To: Steven Ledoux, Town Manager **Date:** February 19, 2009
From: Scott A. Mutch, Zoning Enforcement Officer & Assistant Town Planner
Subject: Site Plan Special Permit Application #06/05/07-411 - **Amendment**

Location: 253 Main Street
Applicant: Ken Sundberg, 20 Henley Road, Acton, MA 01720
Owner: The Sundberg Family Acton
Nominee Trust
Zoning: Kelley's Corner (KC)
Groundwater Protection District Zone 4
Hearing Date: February 23, 2009 (Original Hearing: January 26, 2009)
Decision Due: April 26, 2009

Project: 253 Main Street
Acton, MA
Landscape Plan dated 11/10/2008

To: Scott Mutch, Planning Department *Date:* 2/6/09
From: Dean A. Charter, Municipal Properties Director
Subject: Landscape review, 253 Main Street (Sundberg) Amendment

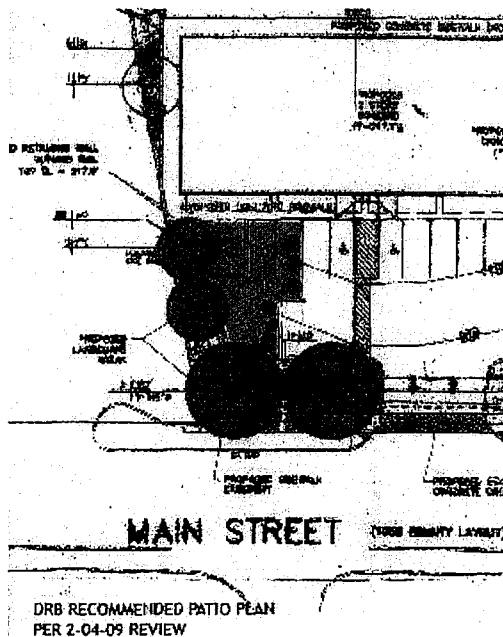
- ☐ The DRB recommends expanding the outdoor patio seating area to enhance look-and-feel of the site and improve its attractiveness as a pedestrian destination, per Acton Master Plan (1998), Kelley's corner Specific Area Plan (1995) and Acton Design Review Guidelines (2007); (see recommended drawing below)
- ☐ The DRB notes the Board initiated Zoning change in 2007, at Mr. Sundberg's instigation, to make open patio/café dining feasible in Acton, specifically with this project in mind. (With the Planning Board's assistance this zoning change passed unanimously at 2008 Town Meeting.) See posted Meeting Minutes, 8/22/07, on Town web site.
- ☐ The DRB recommends the proponent provide an elevation of the tall block retaining wall at the back of the site, showing scale, type, safety features if necessary, impact on surroundings.
